## **SF Creek: Meetings and Communications Involving the Water Board since Initial Application for Certification (BHW – 6/25/14)**

**Title of Project: San Francisquito Creek Flood Reduction, Ecosystem Restoration and Recreation Project**

## **Flood Control 2.0 Workshop I: *San Francisquito Creek Flood Reduction, Ecosystem Restoration and Recreation Project, San Francisco Bay to Highway 101* SFEI, 8/31/2012**

**Subject: Application for Water Quality Certification for San Francisquito Creek Project,  
Santa Clara and San Mateo Counties**

PROJECT NAME AND SHEET DESCRIPTION:  
**SAN FRANCISQUITO CREEK**  
**FLOOD REDUCTION, ECOSYSTEM**  
**RESTORATION, & RECREATION PROJECT**  
**GENERAL SITE PLAN**

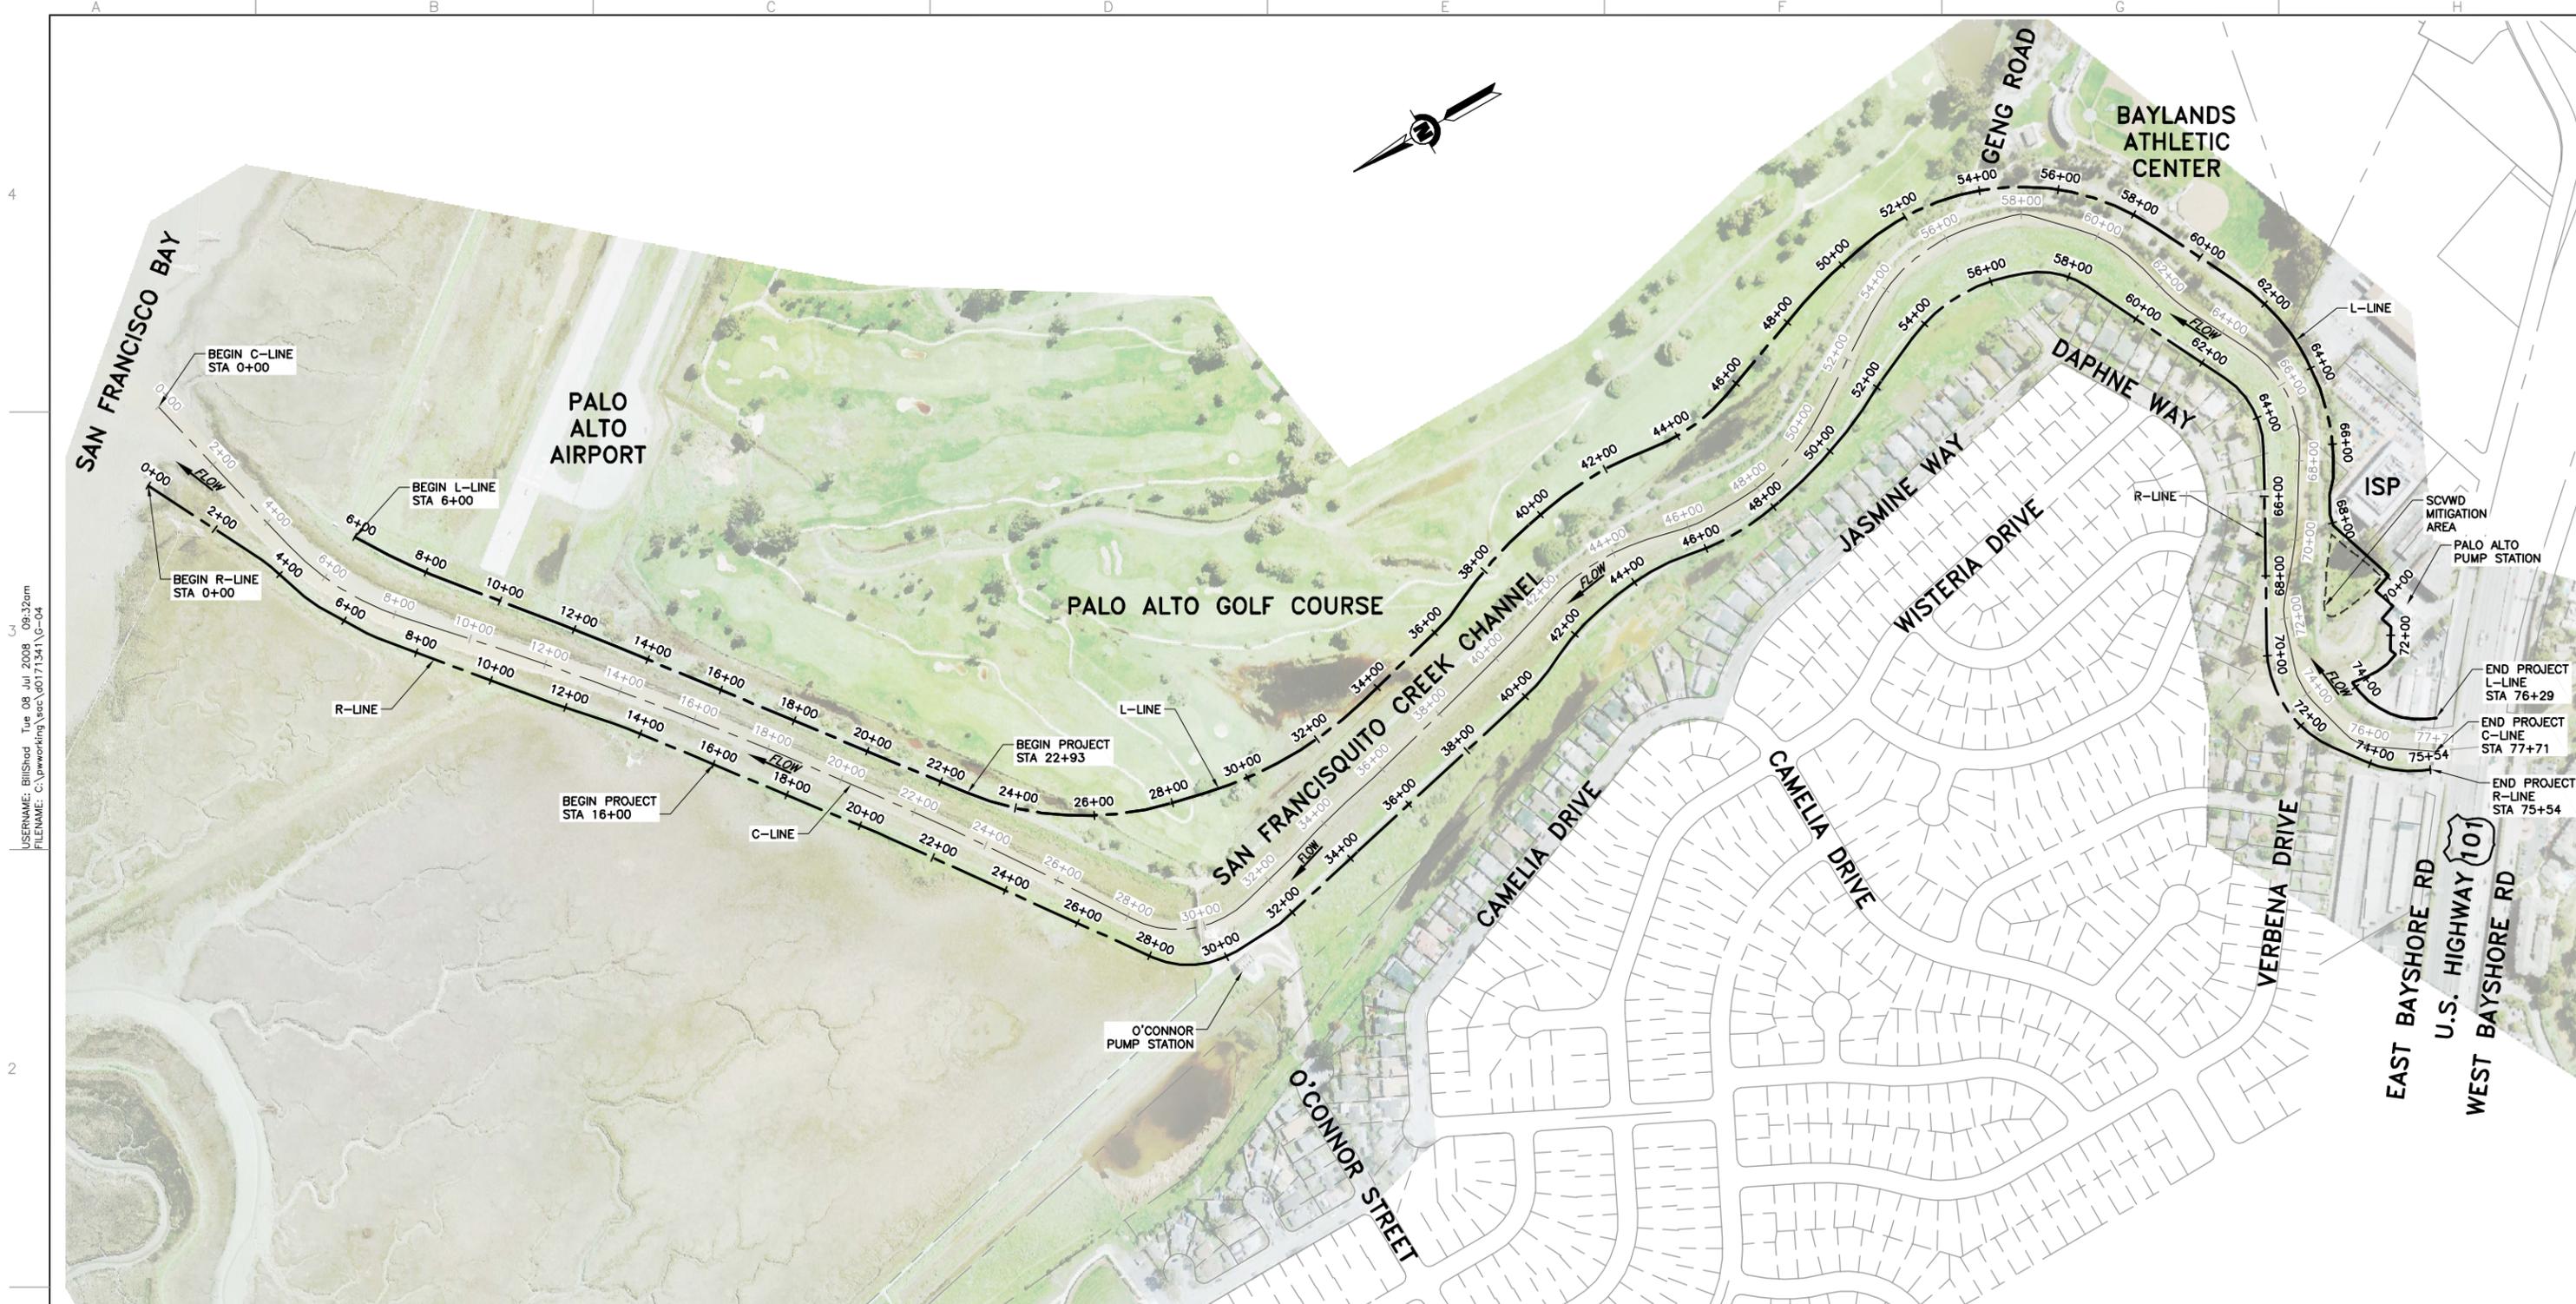
**White line: existing levee location**  
**Orange line: proposed levee location**  
**Green line: floodplain**  
**Width of floodwall to floodwall: 138 feet**

Setting the levee back into the golf course can provide flood safety benefits, lowering the water surface elevation particularly for the more common 5300-7400 cfs discharges ( up to the thirty year flood). However, environmental benefits include lowering the velocities and shear stresses and creating a better environment for marsh plain establishment. A wider project area between levees could add a floodplain next to the marsh plain providing additional upland vegetation, and if the levees are constructed at a more gentle slope, creation of functioning marsh is more feasible.

For illustration of a planning method, a map is provided which illustrates a minimum additional setback scenario of an average of 56 feet from the proposed project golf course levee from station 15+00 to the start of the proposed floodwall at 54+00, or 3,900 lineal feet. This scenario would add 5 acres to the stream environment and reduce the golf course acreage to approximately 151 acres. The floodplain space would still be below a typical drainage area-floodplain width for similarly sized watersheds in the Bay Area. This minimal scenario would allow more roughness (0.04 - 0.05) without raising the flood levels. This type of scenario review could provide a better balance between the golf course and the creek.

SFCreek\_FT\_HDR\_060614 Plan: 1) NoOvrt\_SFDEg 2) LARGER Setback

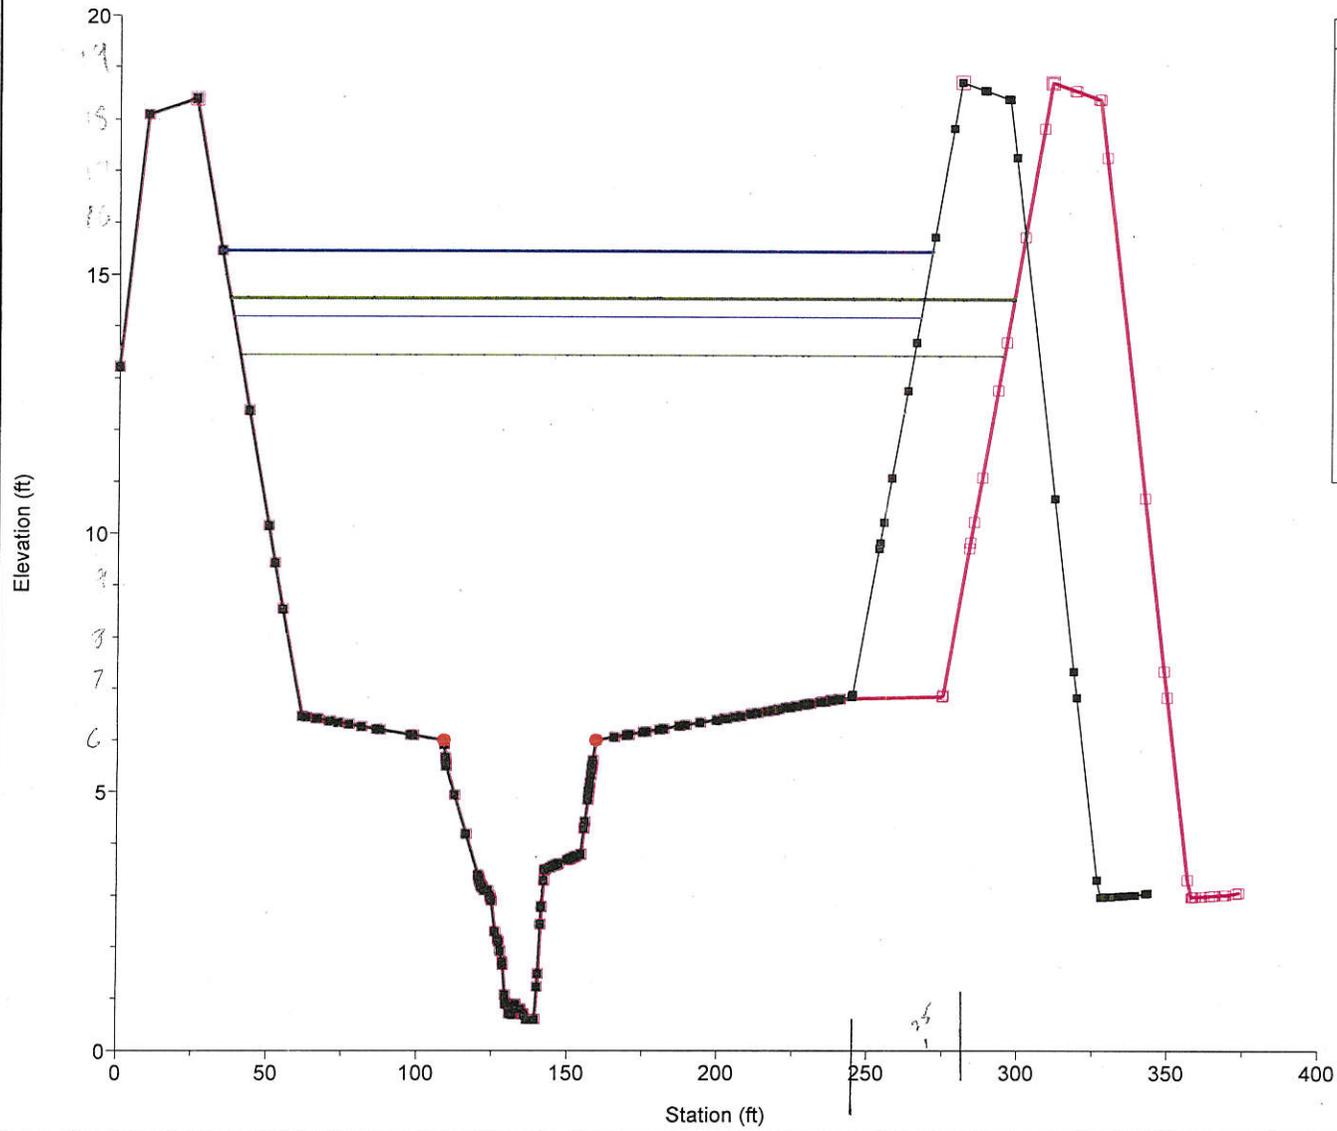
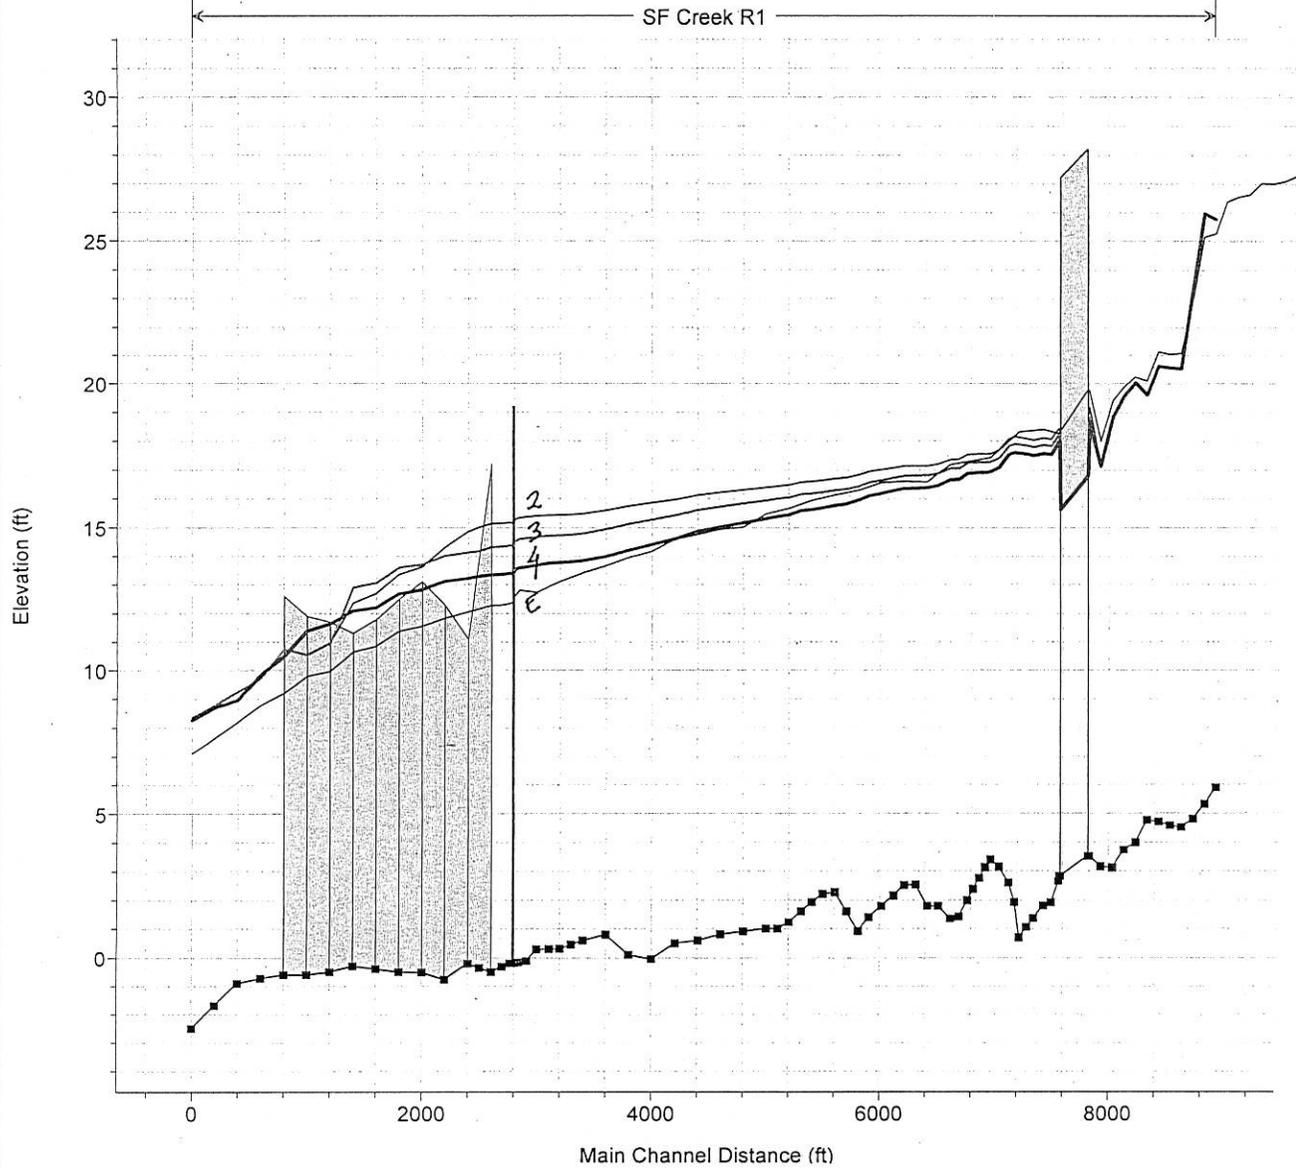
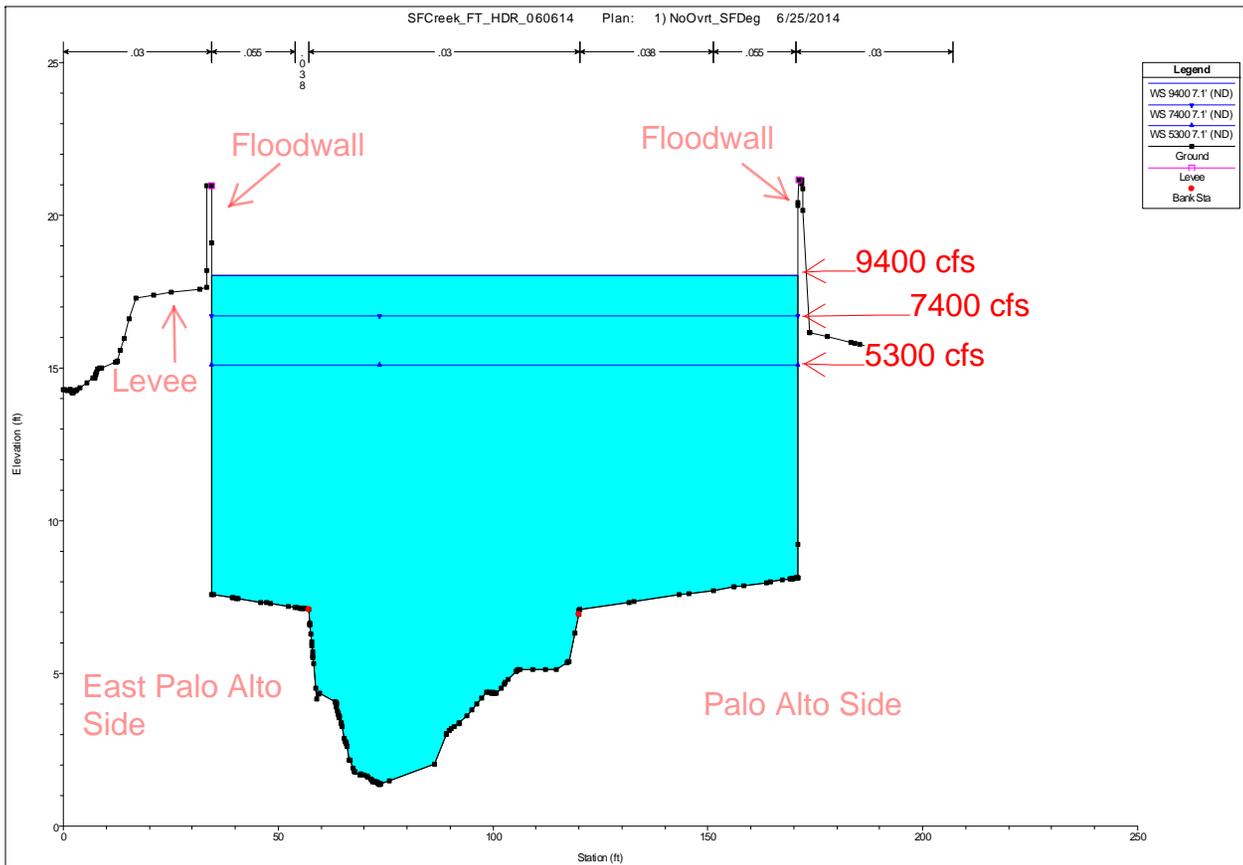
"E" Existing – Doesn't include new Hwy 101 culvert to go in this summer

- 2. Faber track berm filled in and triangle parcel flair
- 3. Faber Tract berm filled in, triangle parcel flair, and partial levee setback
- 4. Faber Tract berm filled in and levee setback
